# Memorandum

**TO:** Columbia River Crossing Task Force  
**FROM:** CRC Pedestrian and Bicycle Advisory Committee (PBAC)  
**SUBJECT:** PBAC Recommendations for World Class Pedestrian and Bicycle Facilities

## **Purpose of this Memorandum**

# Pedestrian and Bicycle Advisory Committee Recommended Pathway on West Side of West Replacement Bridge (Looking North)

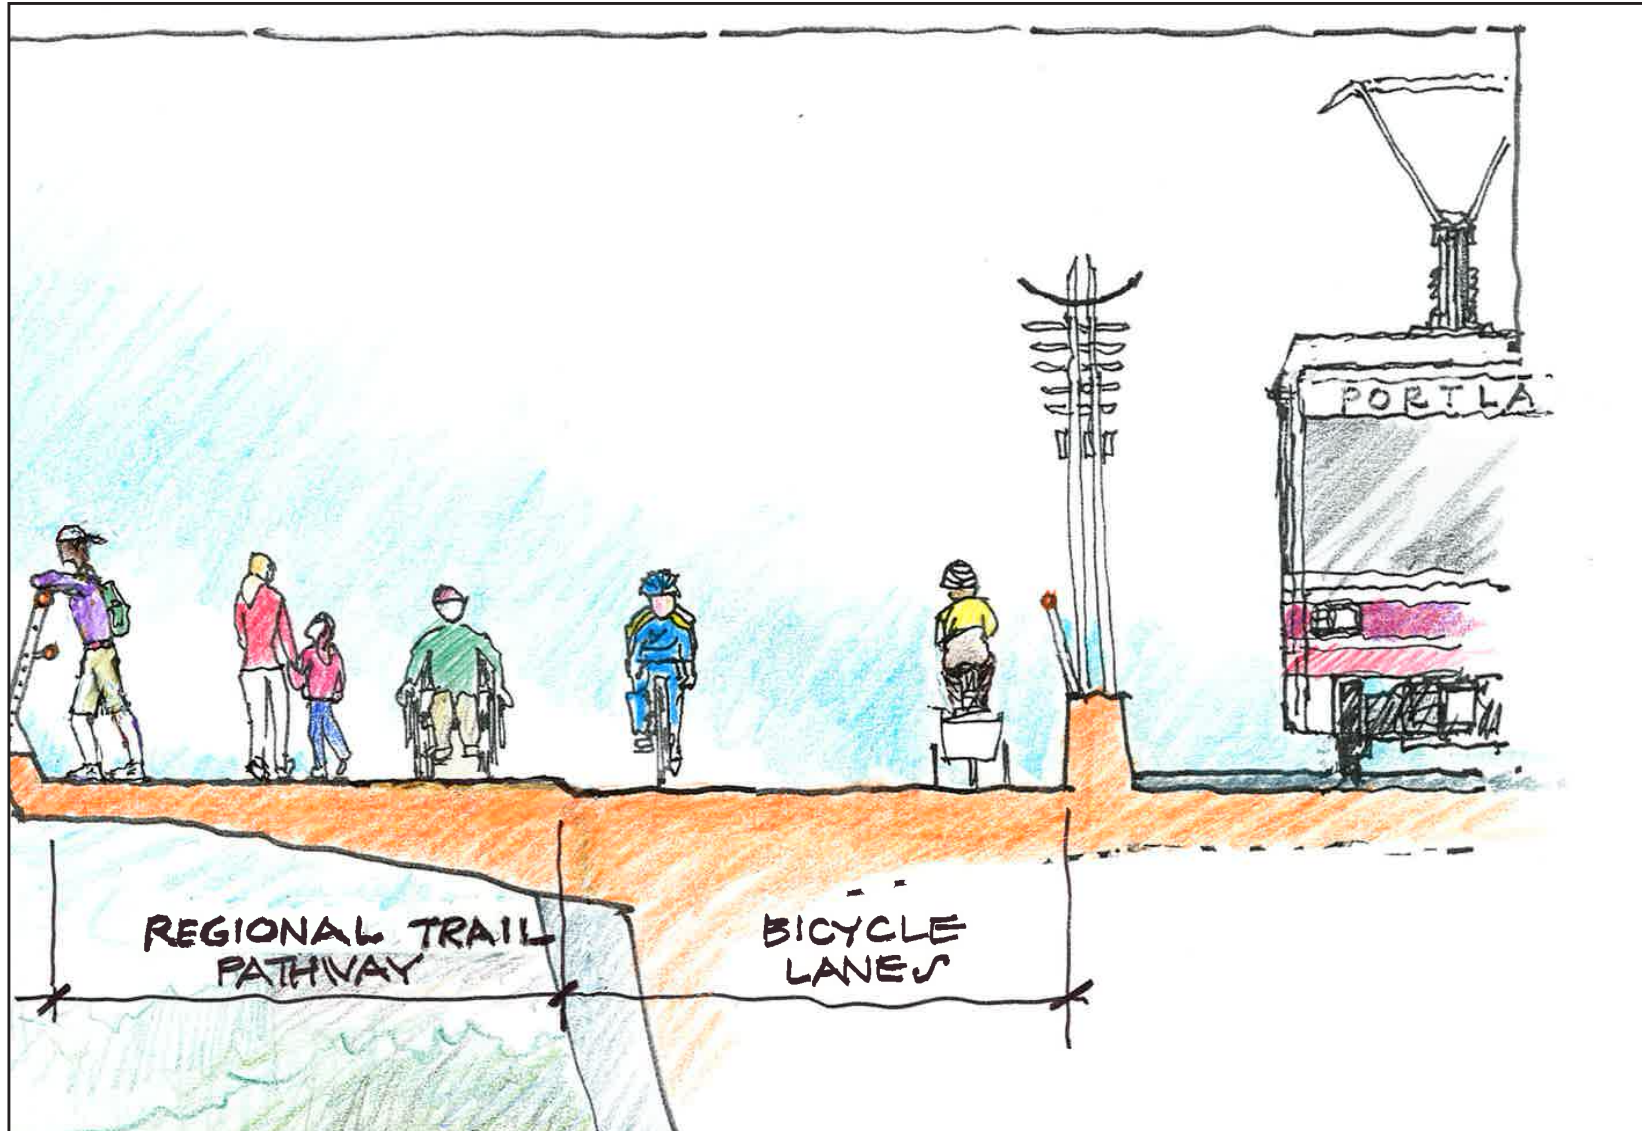
- The overall pathway on the western bridge (adjacent to the transit guideway) must provide separation between recreational users and higher speed bicycle users. To provide this separation, a 12-foot wide regional trail should be provided adjacent to, and to the west of, a pair of six-foot wide bicycle lanes (see attached rendering). These recommended widths are exclusive of potentially needed shy distances, i.e., free and clear of poles and other obstructions to enable safe pedestrian and bicycle movement (a summary of agency standards for multiuse paths, sidewalks and bike lanes is attached).

The regional trail would accommodate pedestrians, persons with disabilities, seniors, families with children, tourists, roller-skaters, and recreational bicycle riders. The adjacent bicycle lanes would be used by bicycle commuters and other faster-moving bicyclists. The regional trail would be at a slightly higher level than the bicycle lanes, but bicyclists in the bicycle lanes would be able to access the trail. Different paving treatments and/or patterns should differentiate the regional trail and the bicycle lanes.
